**SUBJECT:** HILLSBOROUGH COUNTY SOUTHEAST LANDFILL INCOMPLETENESS  
RESPONSE DATED MARCH 24, 1995, RECEIVED BY THE FDEP ON  
MARCH 27, 1995, PENDING OPERATING RENEWAL OF PERMIT #  
SO29-158504

Per our conversation, this memo is to memorialize EPC's comments and concerns regarding the above subject facility incompleteness response report.

**SUBJECT:** HILLSBOROUGH COUNTY SOUTHEAST LANDFILL INCOMPLETENESS  
RESPONSE DATED JANUARY 13, 1995, PENDING OPERATING  
RENEWAL OF PERMIT # SO29-158504

## **SOUTHEAST HILLSBOROUGH LANDFILL - WELL STATUS**

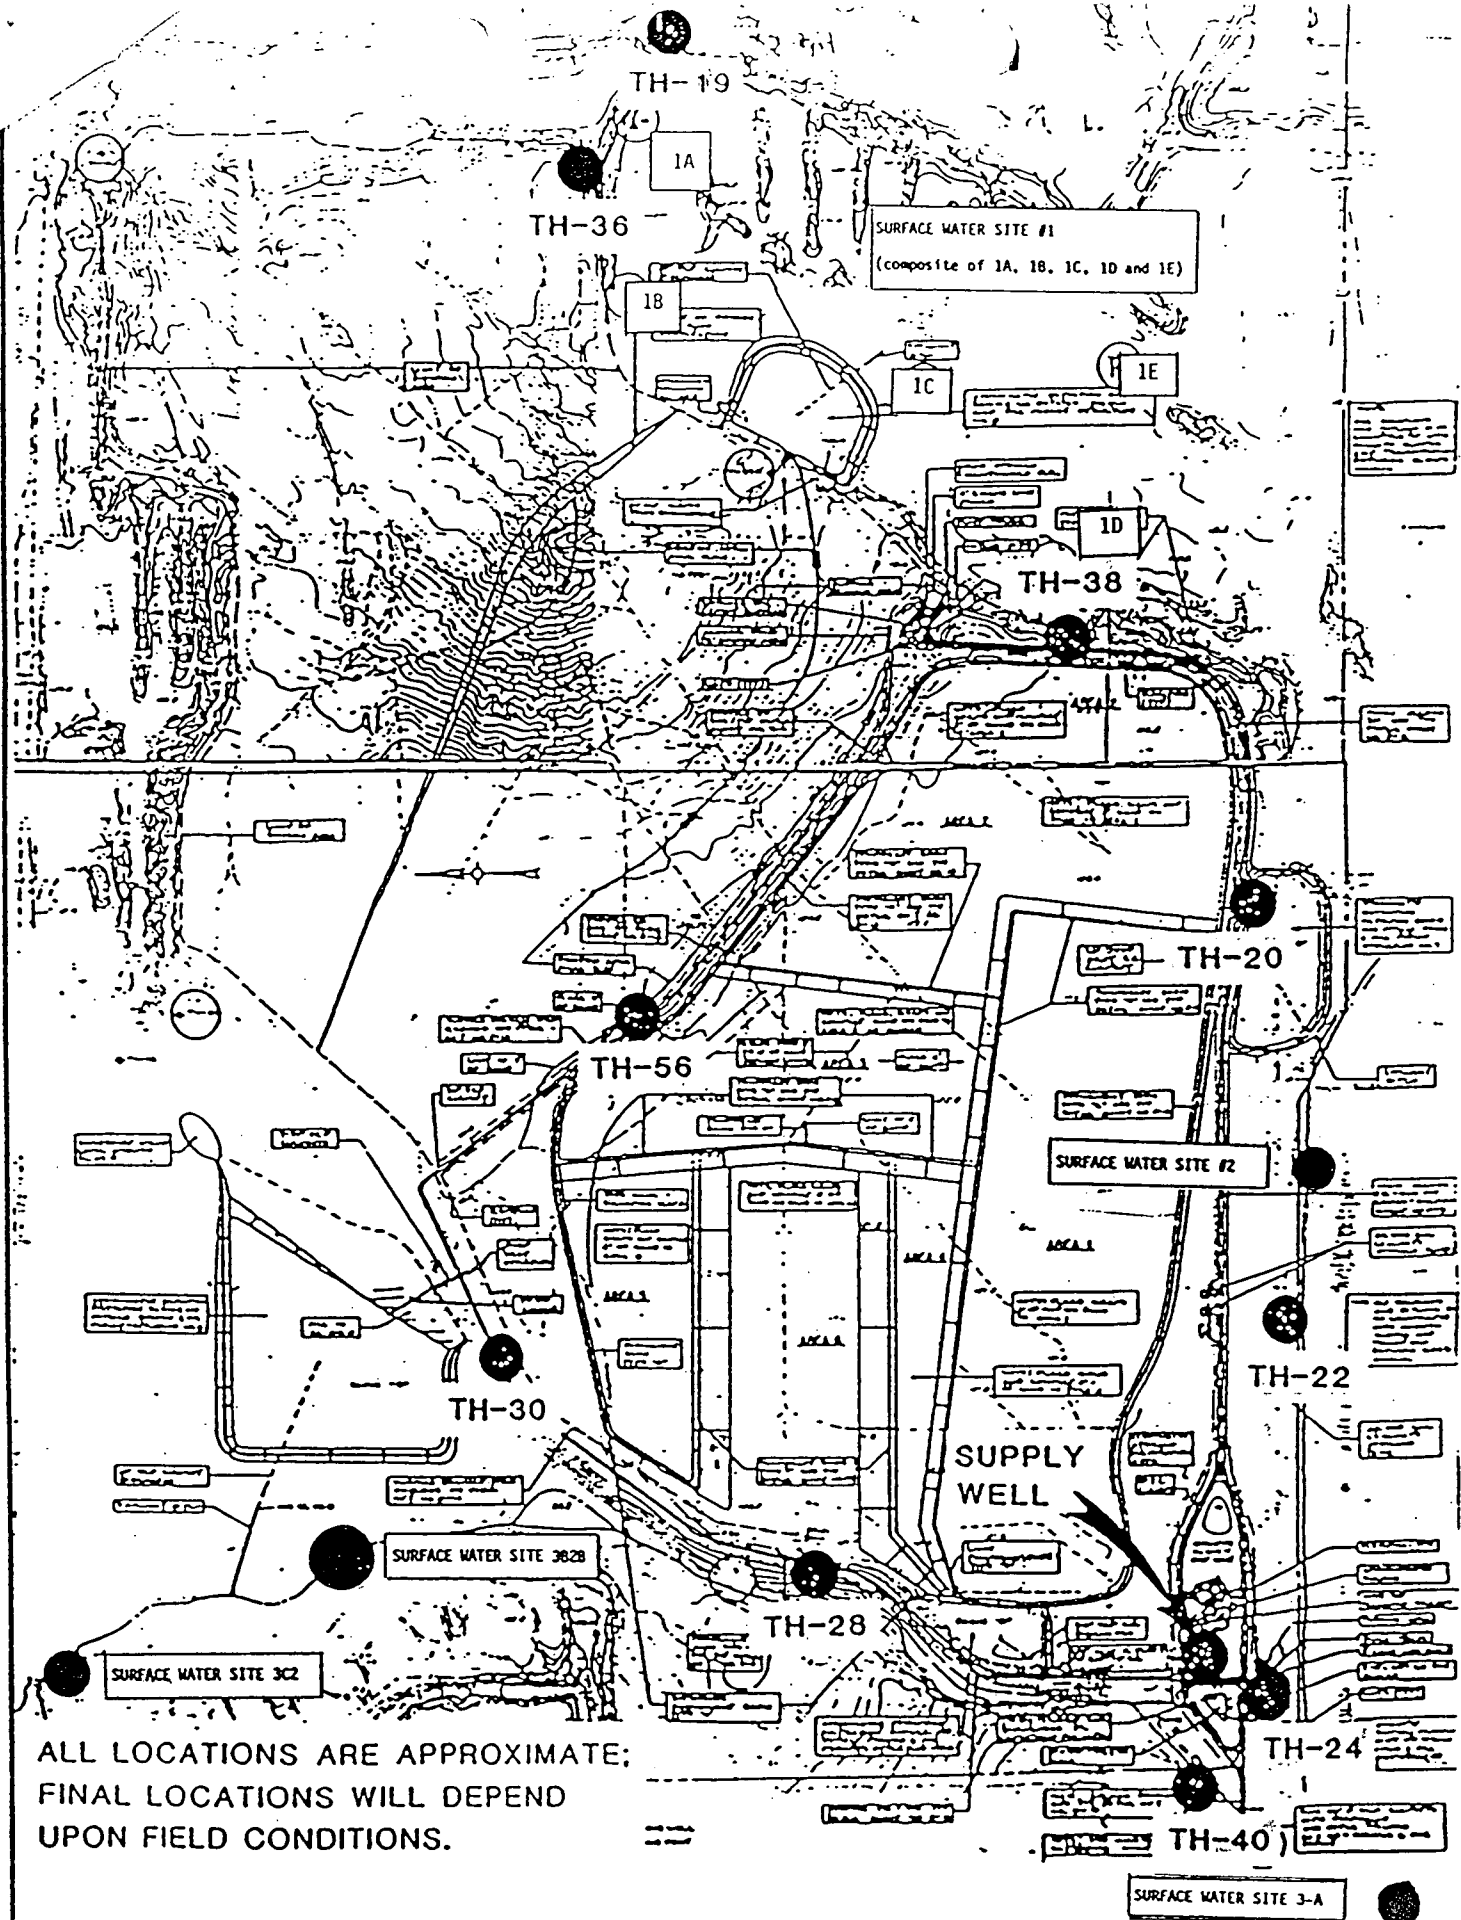
**What is the status of TH-38/TH-38A? Which one is a boring or abandoned?**

Figure 2. Existing Temporary Pump Station No. 3 (Phase VI).

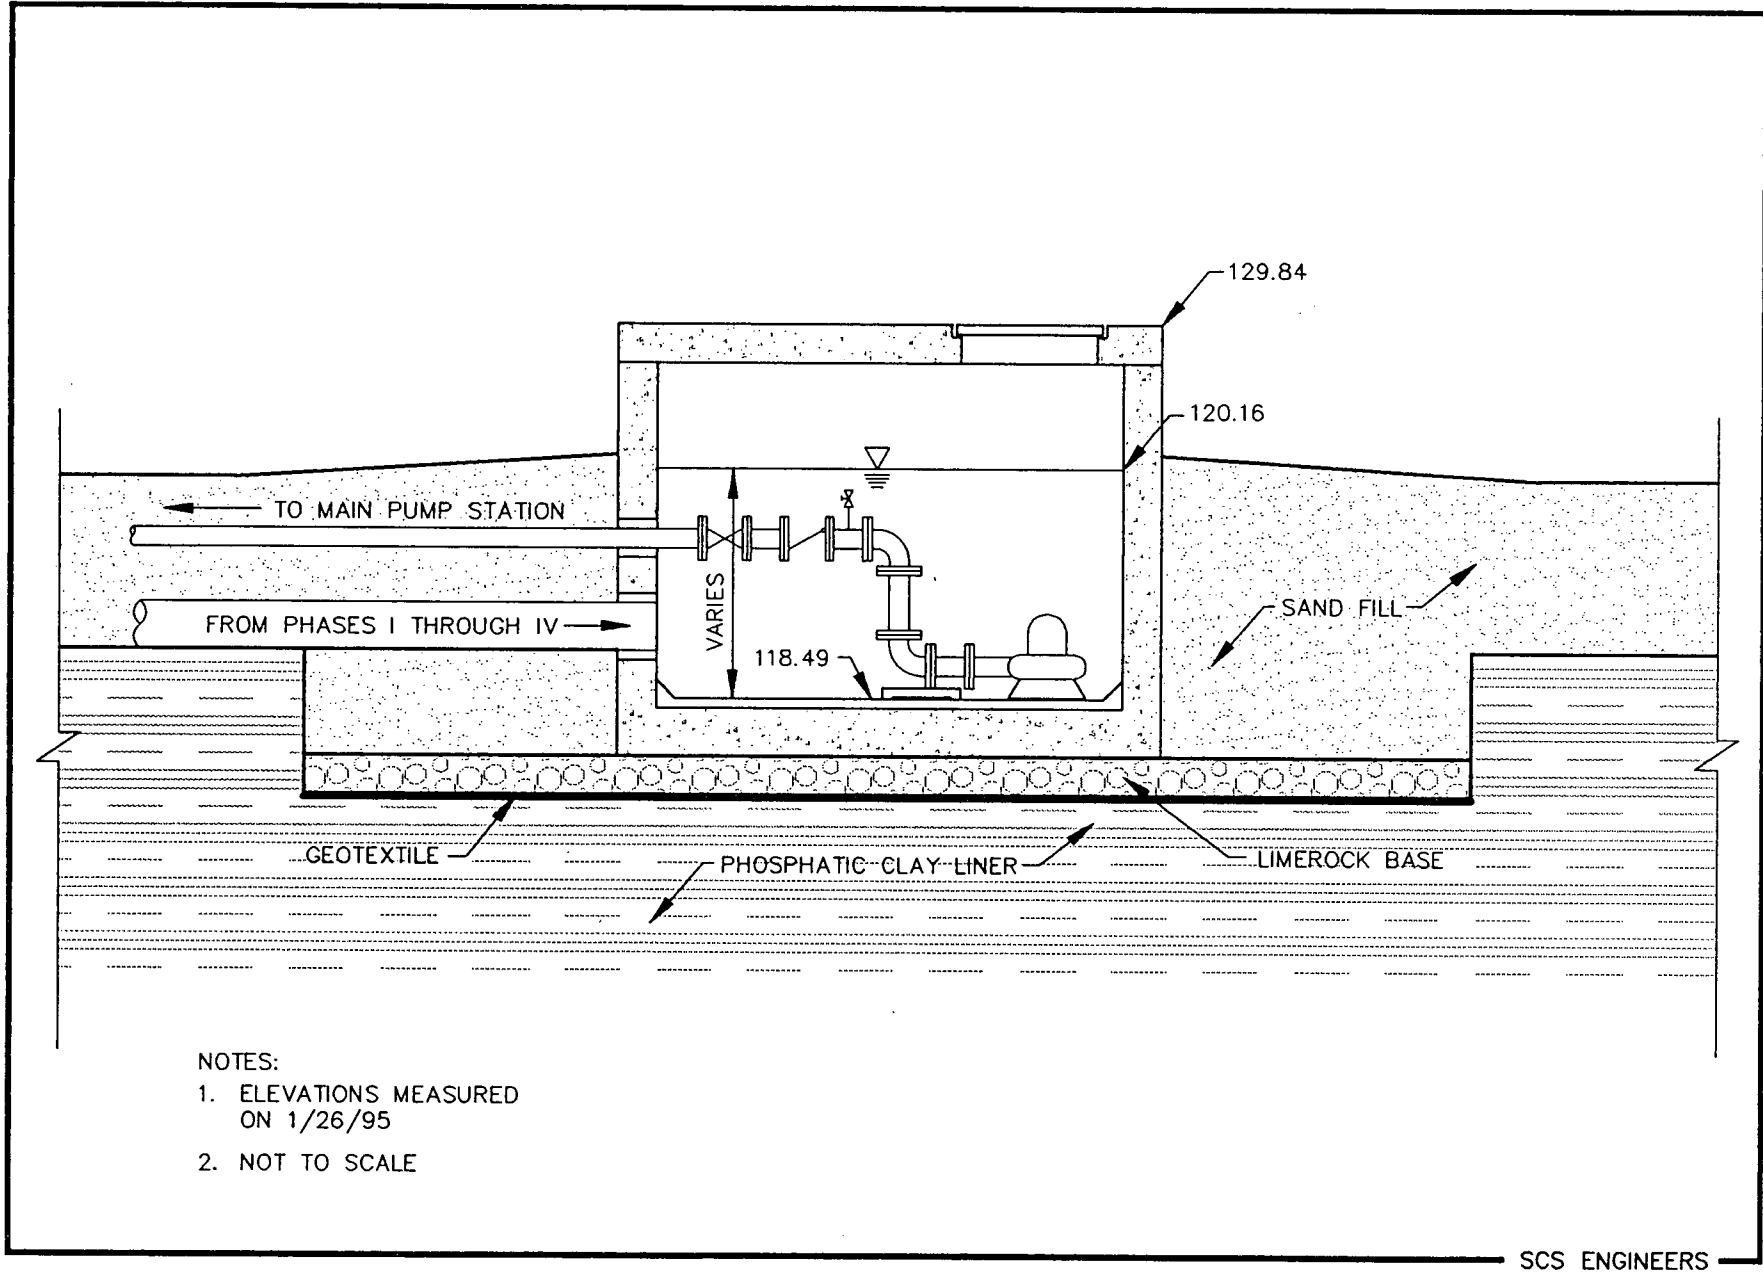
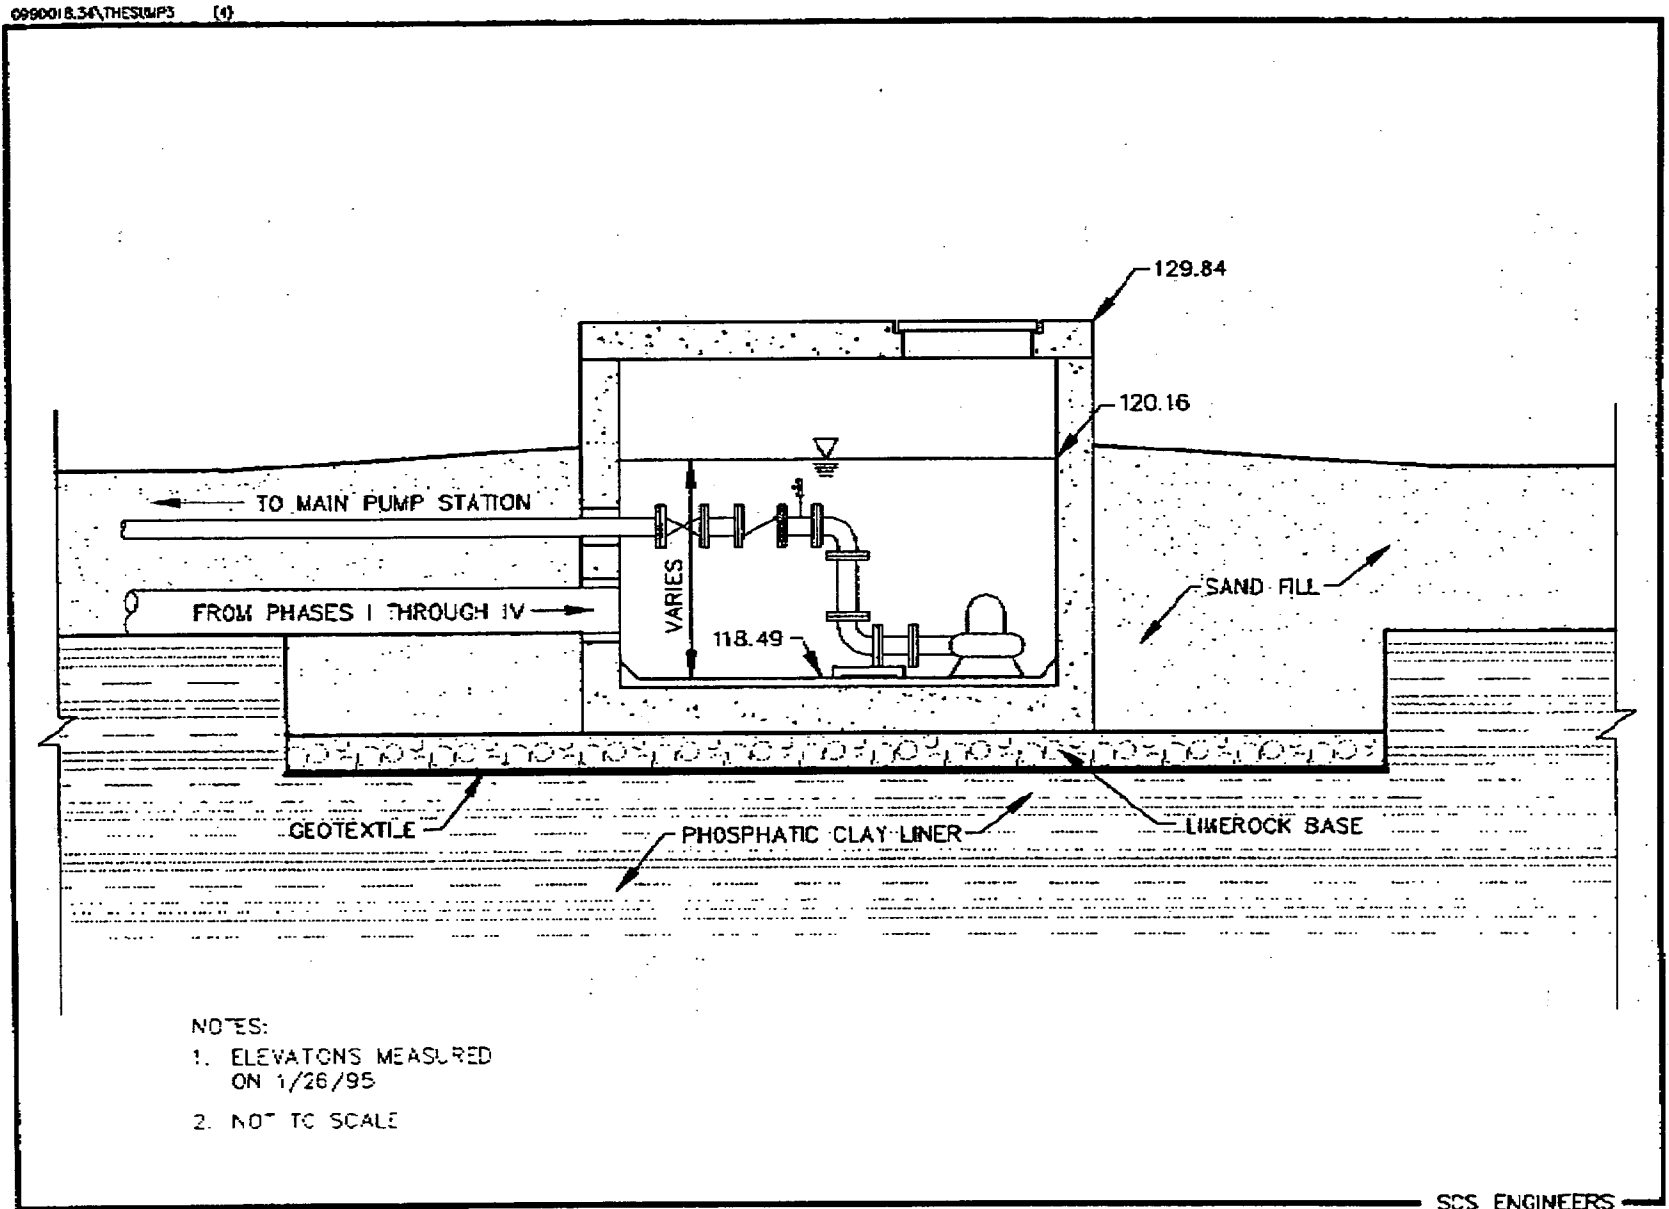
- 1) EPC's primary concern focuses around the leachate management plan, the HELP model, and Figure 2. Based on our meeting with the applicant on January 31, 1995, it was agreed that a leachate management plan that revealed a need for additional storage over peak rainfall periods would be provided. A maximum of approximately 2 to 2.5 feet was agreed to. However, it was also agreed that the leachate management plan would indicate that the landfill would be emptied to one foot of depth as much as possible. According to the text this should be the case; however, it is not my impression of what has been submitted based on Figure 2. For Figure 2. to represent what is envisioned, line B should reflect expected normal operations and line A represent worst case, then the figure and plan should be in the spirit of the agreement. It would appear now, that it is the applicant's intent to operate at in the worst case conditions or line A in Figure 2.

4. Figure 2. presented in SCS's recent response shows a maximum depth of 1.7 feet to start with at the time the new permit is issued and no more than 2.3 feet at any time over the next 5 years. DEP has agreed that a constant 1 foot depth would not be required for this landfill and would allow 2 feet for a limited time to recover from the wet season each year. Figure 2. shows that if the landfill starts with the proposed 1.7 feet, the depth of 1 foot would never be reached. I may be willing to accept a starting depth of 1.7 feet, but no more. It appears unreasonable to issue a new permit for the SE Landfill with current site conditions that do not comply with SCS's performance criteria.

**Response** - The leachate monitoring program was expanded to monitor leachate levels in the existing clean outs in Phases III and IV (See Note 5, Figure 1), and the leachate storage tank at the on-site Leachate Treatment Facility on daily basis. In addition, the water levels are monitored in the temporary pump station No. 4 to maintain the water levels in Phases V and VI at least equal to leachate levels in Phases III and IV so that the 12-inch hydraulic head is not exceeded on the synthetic liner along the interior berms of Phases III and IV. The water depth in the temporary Pump Station No. 4 will be monitored and maintained to a level at least 6 inches higher than the leachate level depth in Pump Station No. 3 (See Figures 2 and 3).
